**Re: Response to Preliminary TAC Comments
Cali Coffee
File Number: 17-DP-03**

RE: *Variance Request Summary*
 Cali Coffee – File Number: 17-DP-03

FINAL T.A.C. DEVELOPMENT PLANS FOR CALI COFFEE HOLLYWOOD

SHEET NUMBER
DP-03

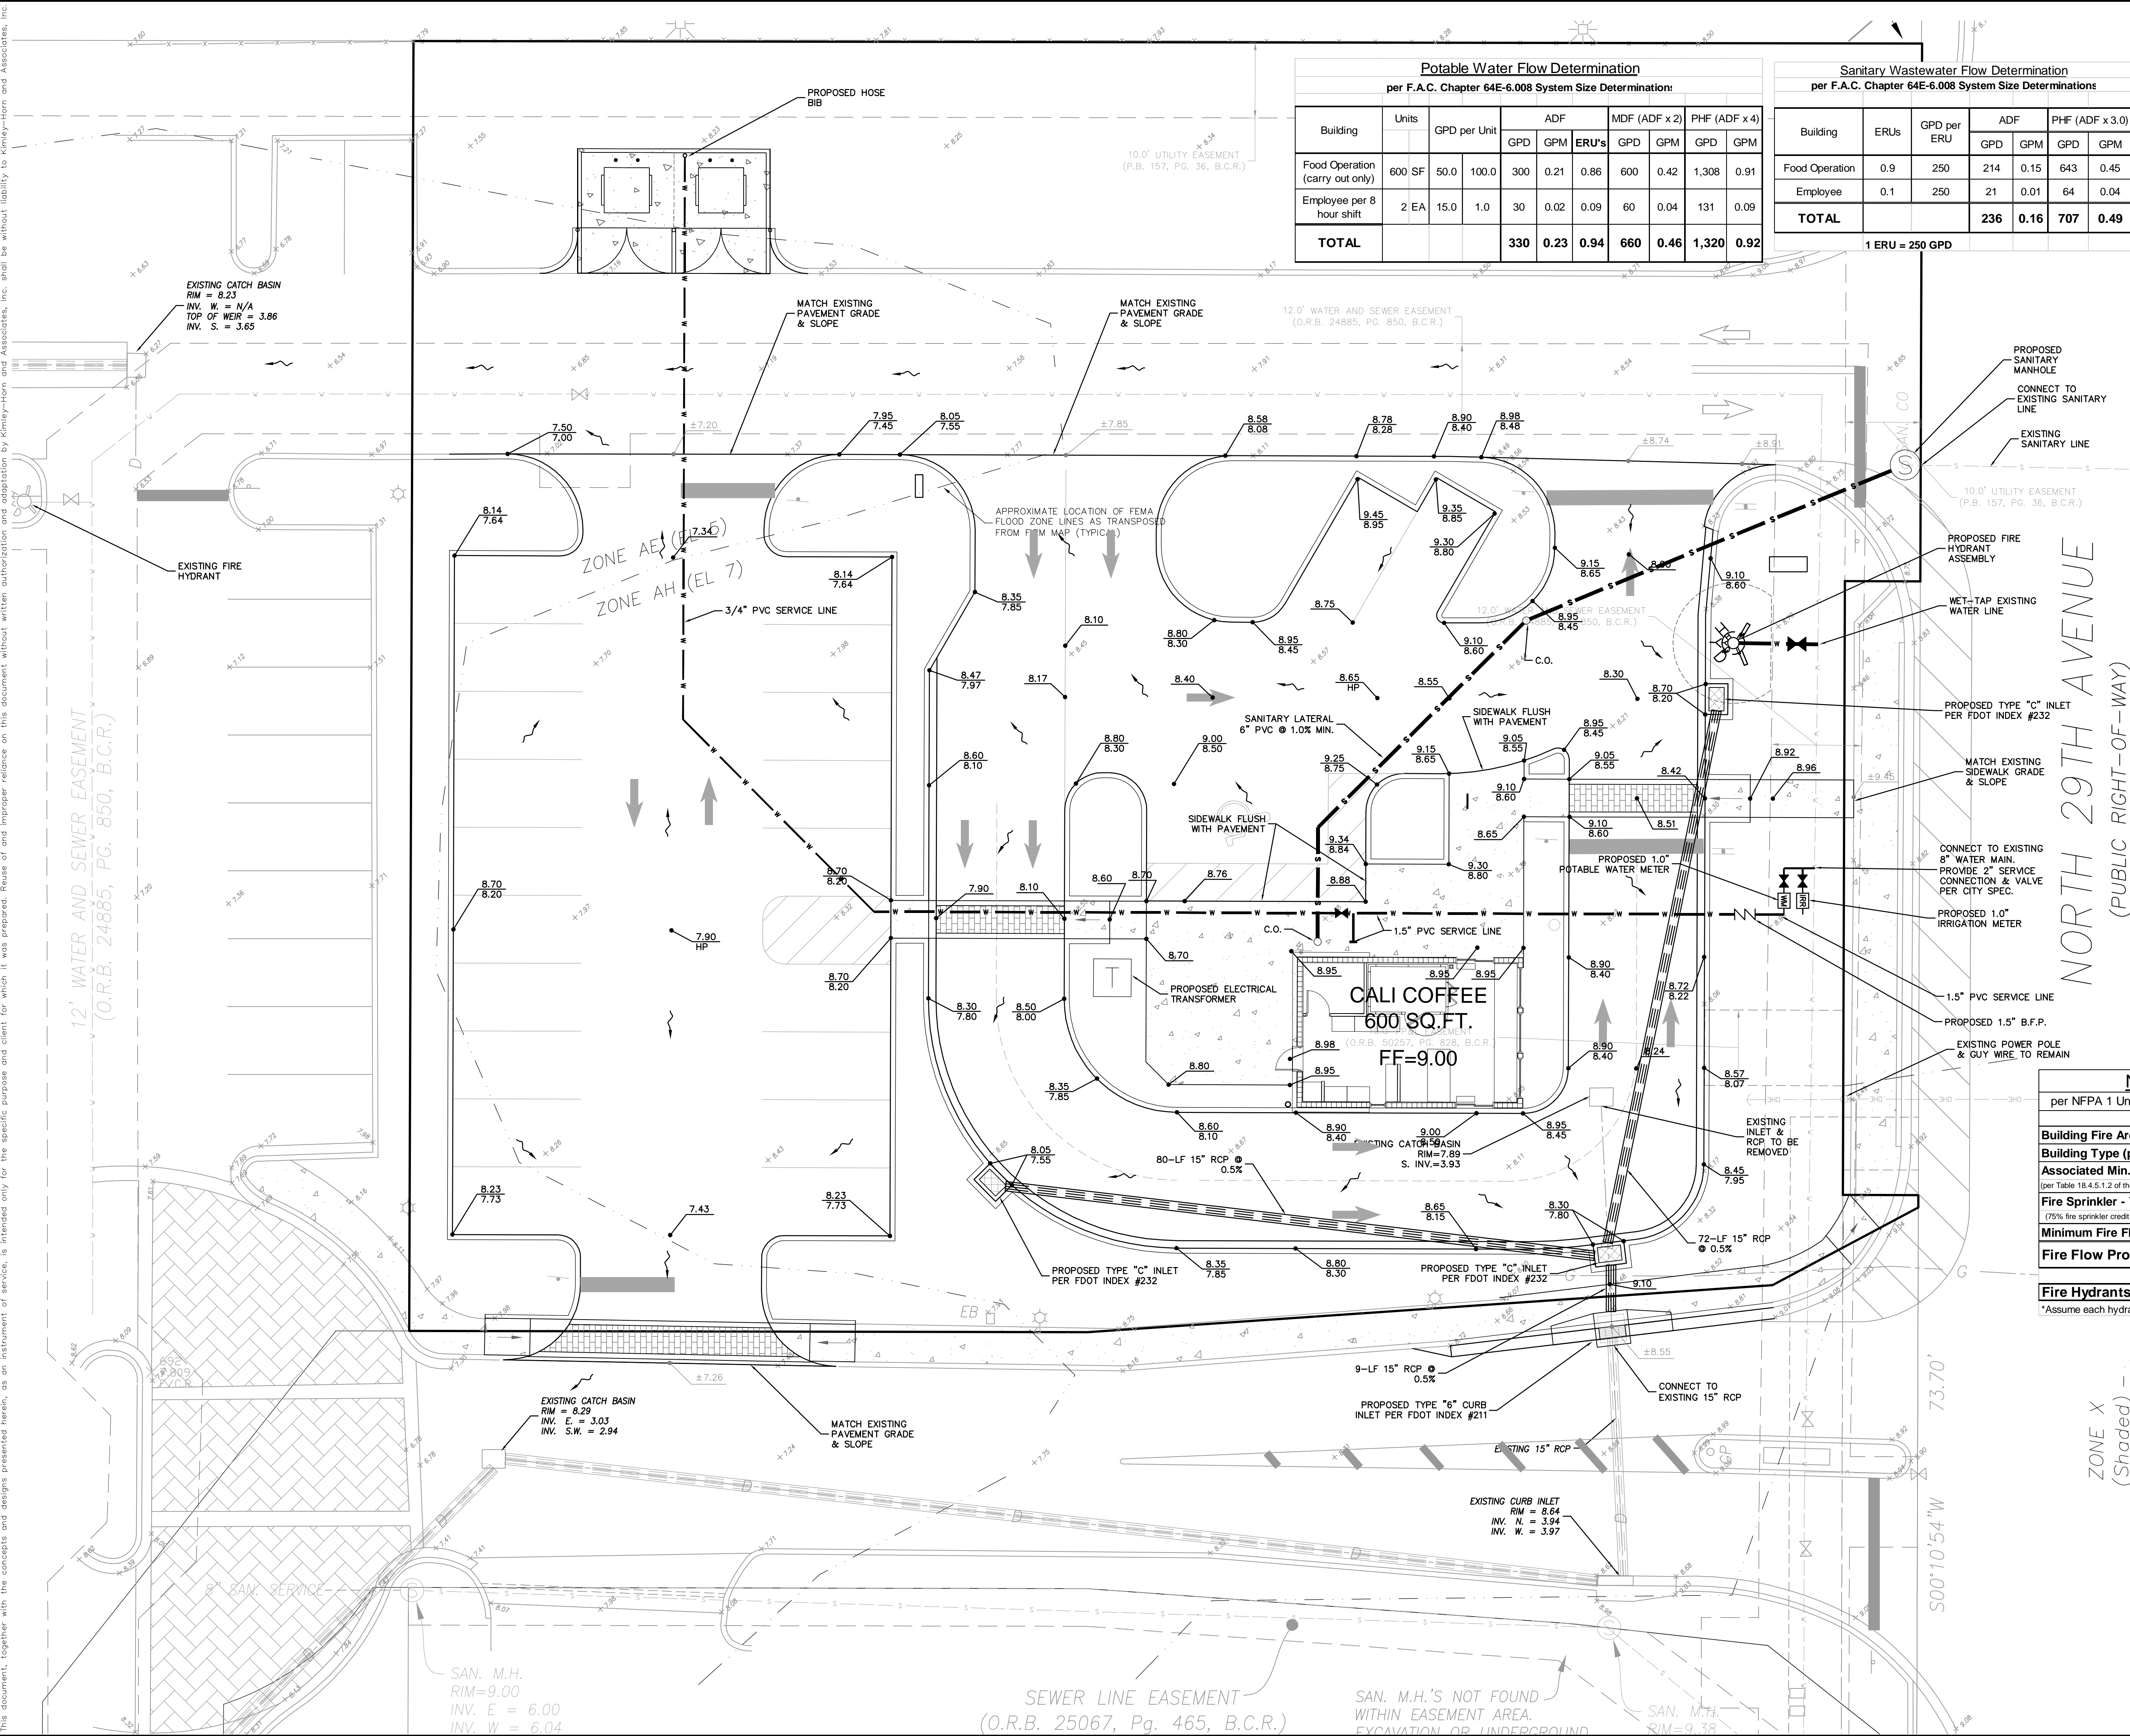
- c. Delete notes "proposed zoning", "existing lot impervious areas".

- d. Update parking table to indicate the correct number of accessible parking spaces provided.

2. The drive-thru needs to accommodate six vehicles of stacking from the first stopping point. The first stopping point is the menu board.

1. On Sheet DP-03, update parking table for the number of accessible parking being provided from 2 to 1.

2. For the angled parking on Sheet DP-03, the minimum stall depth perpendicular to aisle is 21', not 19'. The minimum actual stall depth shall be 19'.

3. Provide all vehicle turning radii on plan.

4. Provide six outbound stacking spaces for the drive thru. The stacking spaces shall be counted from the first stopping point, the menu board.

1. Sheet DP-03, trash containers need to be on wheels to make haulers access to dumpster enclosure function.

3. Sheet DP-03, consider relocating transformer from proposed location adjacent to North 29th Avenue to the SW side of the site so that it is not easily seen from the street.

4. Sheet DP-03, handicapped parking space in front of building may not function. If a vehicle enters as indicated on plan, the car will be facing east when parked. When exiting the vehicle, the driver will have to negotiate a curb to access the building.

Response: Deleted as requested. Please see revised Site Plan sheet DP-03.

Response: Updated as noted. Please see revised Site Plan sheet DP-03.

Response: The menu board has been removed. First stopping point will be at the order/drive-thru window. Please see revised Site Plan sheet DP-03.

Response: Parking table updated as noted. Please refer to revised Site Plan sheet DP-03.

Response: The parking stall depth was dimensioned as discussed. Please refer to revised Site Plan sheet DP-03.

Response: Provided as requested. Please refer to revised Site Plan sheet DP-03.

Response: The menu board has been removed. First stopping point will be at the order/drive-thru window. Please see revised Site Plan sheet DP-03.

Response: Note for trash container wheels was added to revised Site Plan sheet DP-03.

Response: The proposed transformer has been relocated behind the building. Please refer to revised Site Plan sheet DP-03.

Response: An accessible aisle has been added to the east (front) side of accessible parking space, allowing for additional pedestrian maneuverability. Please refer to revised Site Plan sheet DP-03.

SHEET NUMBER
DP-04

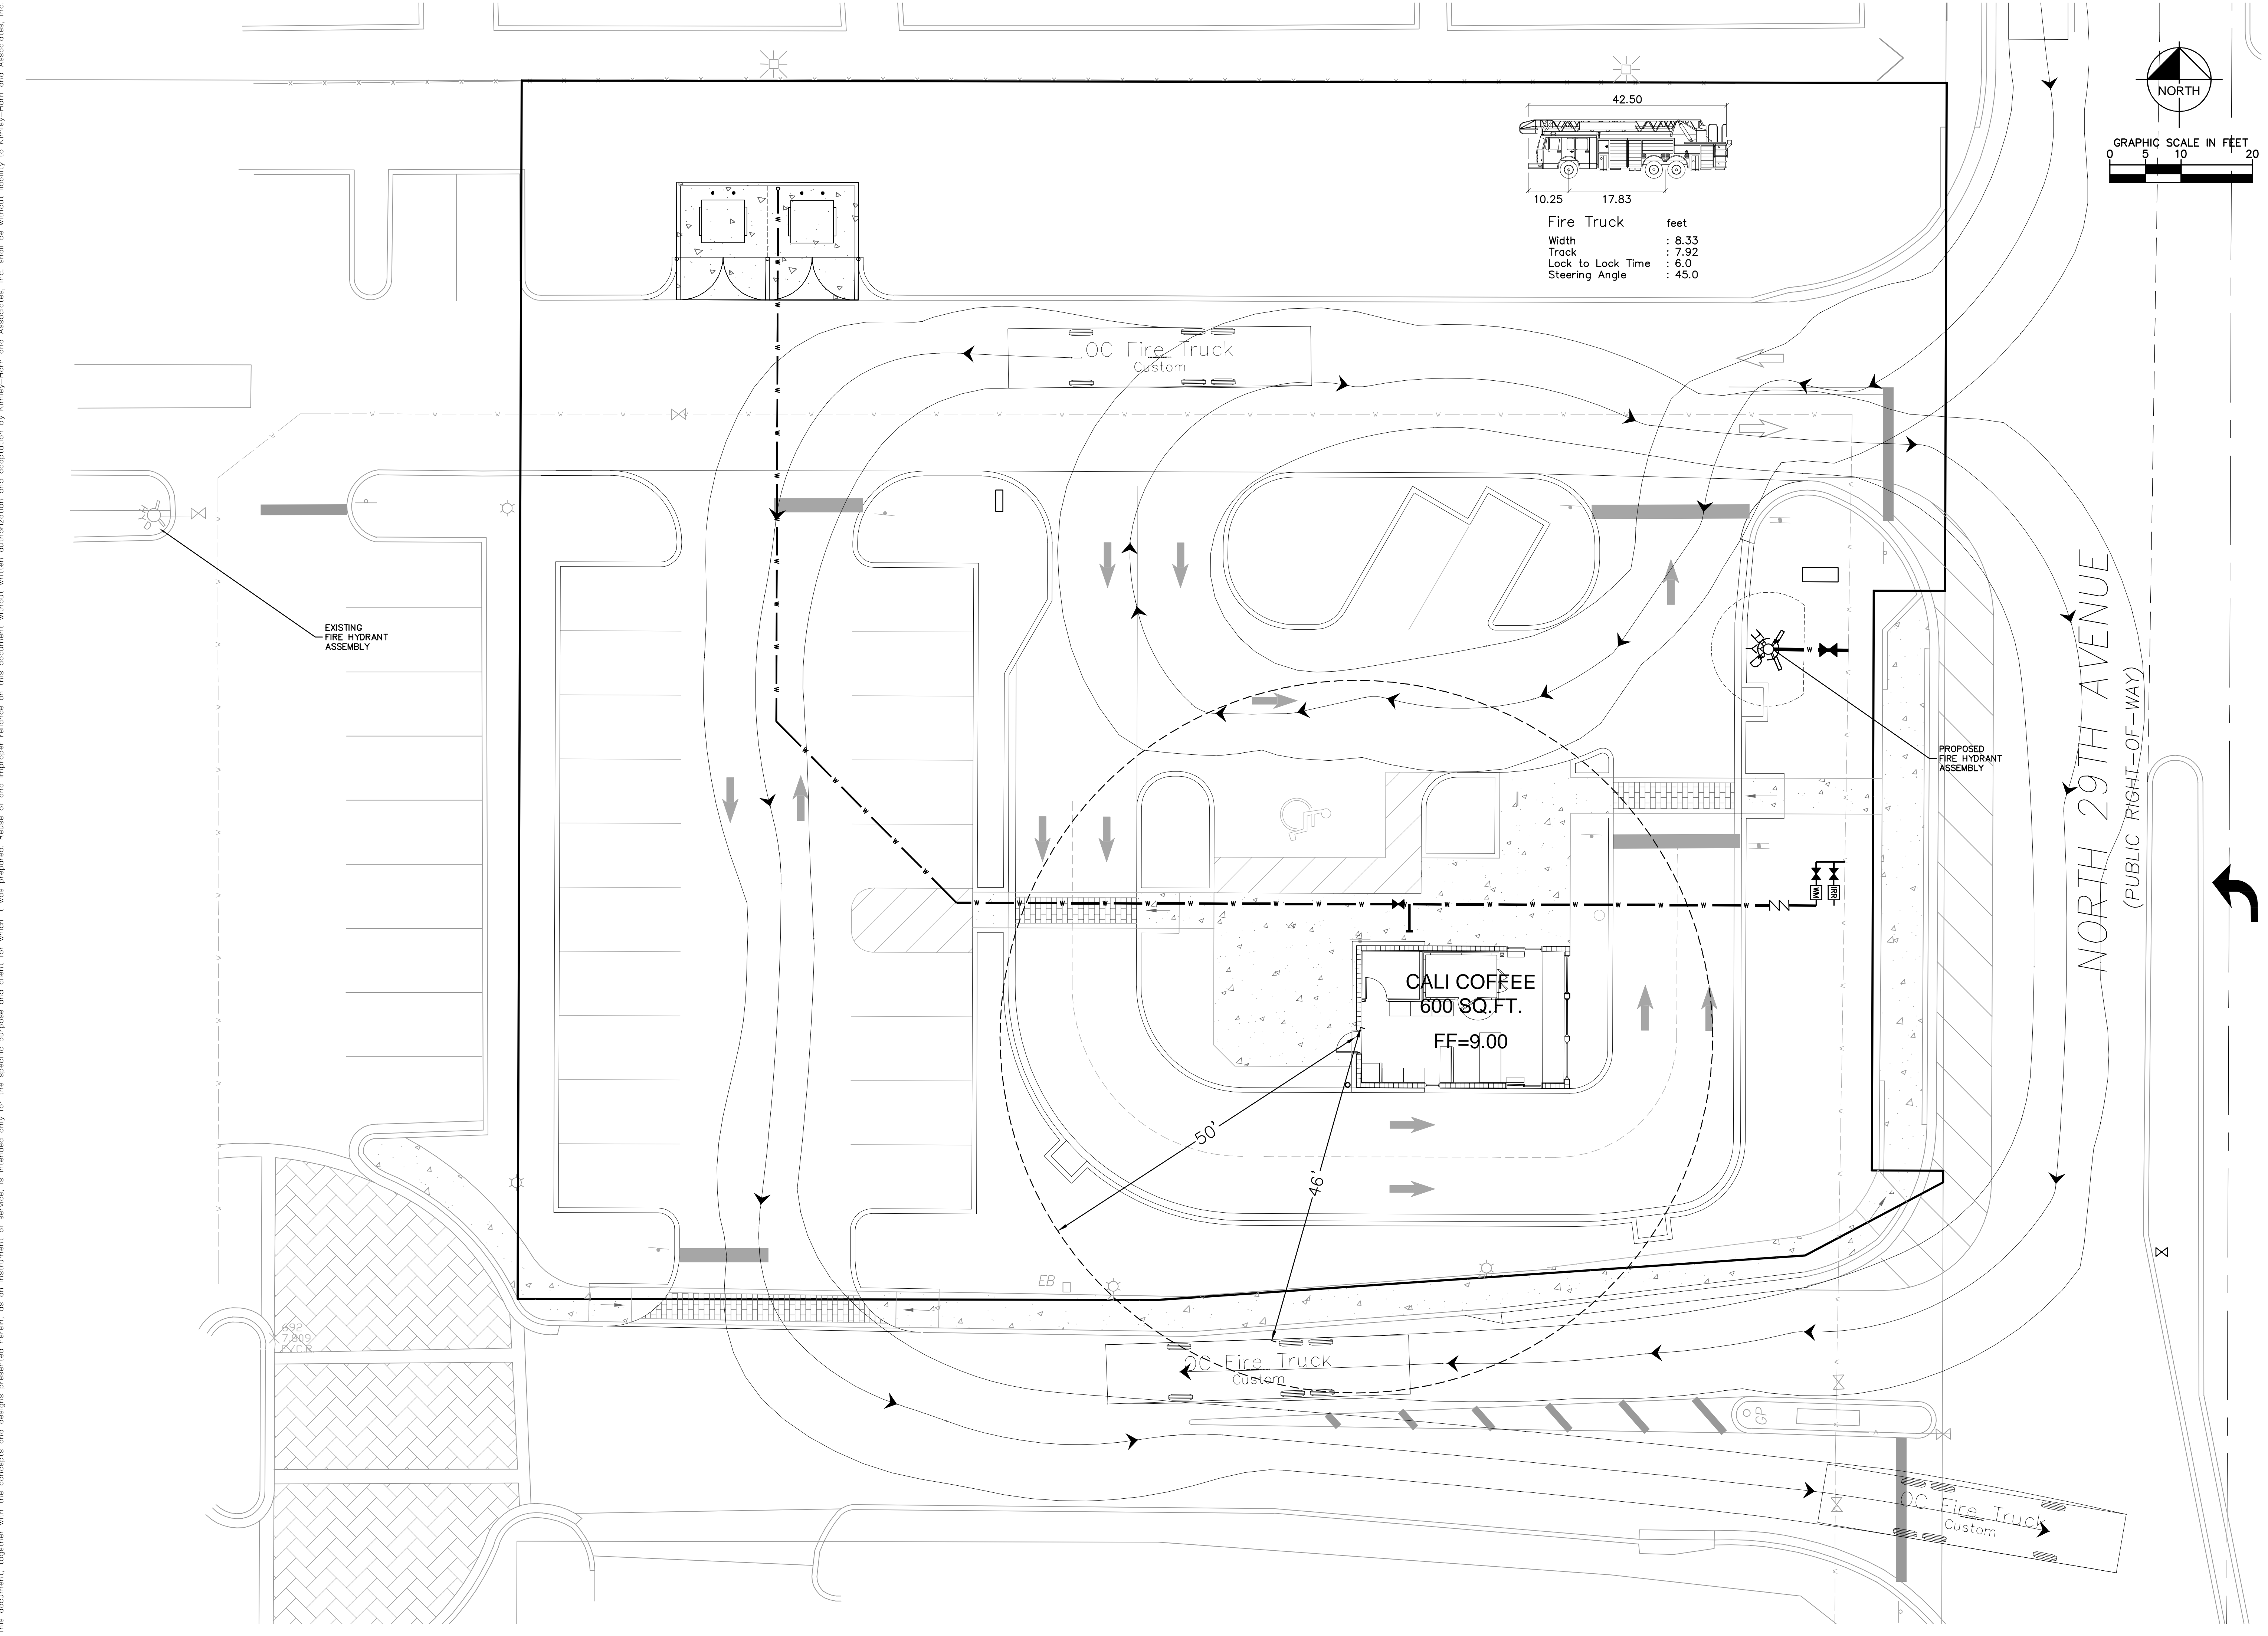
4. Provide water and sewer demand calculations on the civil plan.

5. Plans show proposed backflow preventer within the existing 12-ft wide water main easement. Please review to show it outside of the easement.

6. Indicate what size water meter will be requested. Nibco-Scott T113 LF valves required on 2" and larger water services. Indicate source of irrigation water.

2. Show all new (if required) and existing fire hydrants on civil drawings on the next submittal.

Response: Water and sewer demand calculations (per FAC 64E-6.008) have been provided on the revised Plan sheet DP-04.

Response: The proposed backflow preventer (BFP) has been relocated outside of the existing 12-ft water easement. Please refer to revised Plan sheet DP-04.

Response: Proposed potable water meter size (1.5") noted as requested. Please refer to revised Plan sheet DP-04. Irrigation shall be provided by potable water irrigation meter, as reclaim water is not available within the area.

Response: All proposed (1) and existing (1) fire hydrants are depicted on Drainage & Utility Plan sheet DP-04.
